Errata Sheet V1.0

AT91FR4081-33CI

1. Warning: Additional NWAIT Constraints

AT91FR4081 Errata Sheet V1.0

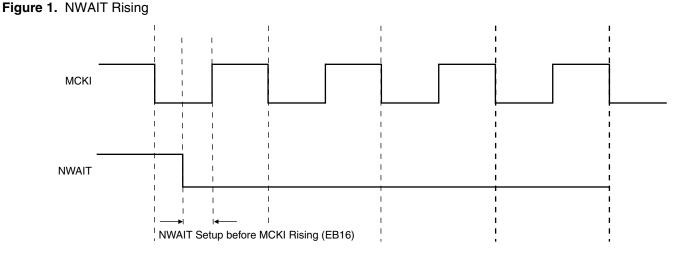
If the NWAIT setup time is satisfied on the first rising edge of MCKI, the behavior is accurate. The EBI operations are not affected when the NWAIT rises.

Figure 2. Number of Standard Wait States is Two

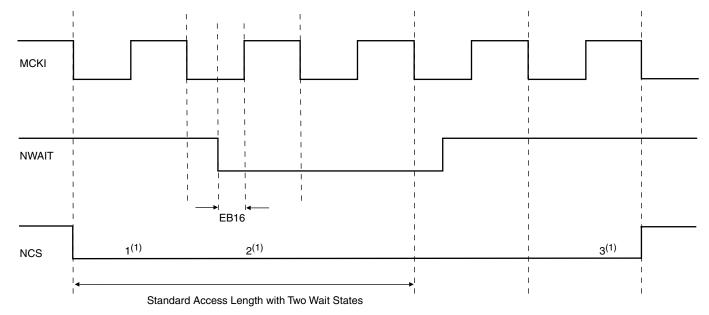
If the NWAIT setup time is satisfied on the following edges of MCKI and if at least one standard wait state remains to be executed, the behavior is accurate. In the following example, the number of standard wait states is two. The NWAIT setup time on the second rising edge of MCKI must be met.

Figure 3. Number of Standard Wait States is One

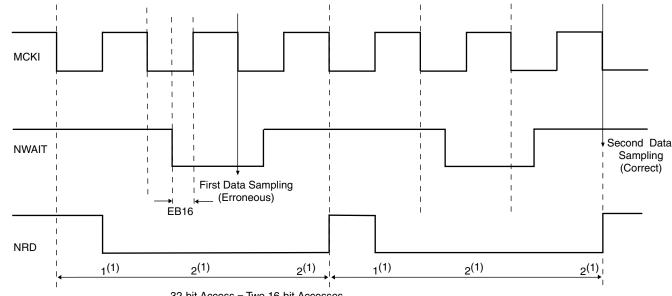
If the first two conditions are not met during a 32-bit read access, the first 16-bit data is read at the end of the standard 16-bit read access. In the following example, the number of standard waits is one. NWAIT assertions do affect both NRD pulse lengths, but first data sampling is not delayed. The second data sampling is correct.

³²⁻bit Access = Two 16-bit Accesses Each Access Length = One Wait State + Assertion for One More Cycle

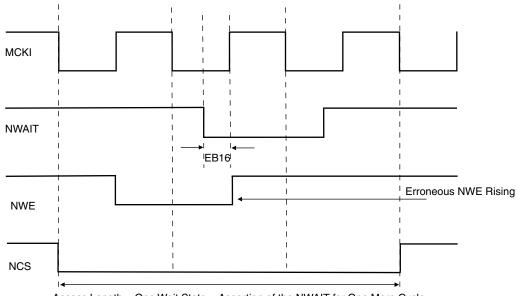
If the first two conditions are not met during write accesses, the NWE signal is not affected by the NWAIT assertion. The following example illustrates the number of standard wait states. NWAIT is not asserted during the first cycle, but is asserted at the second and last cycle of the standard access. The access is correctly delayed as the NCS line rises accordingly to the NWAIT assertion. However, the NWE signal waveform is unchanged, and rises too early.

Access Length = One Wait State + Assertion of the NWAIT for One More Cycle
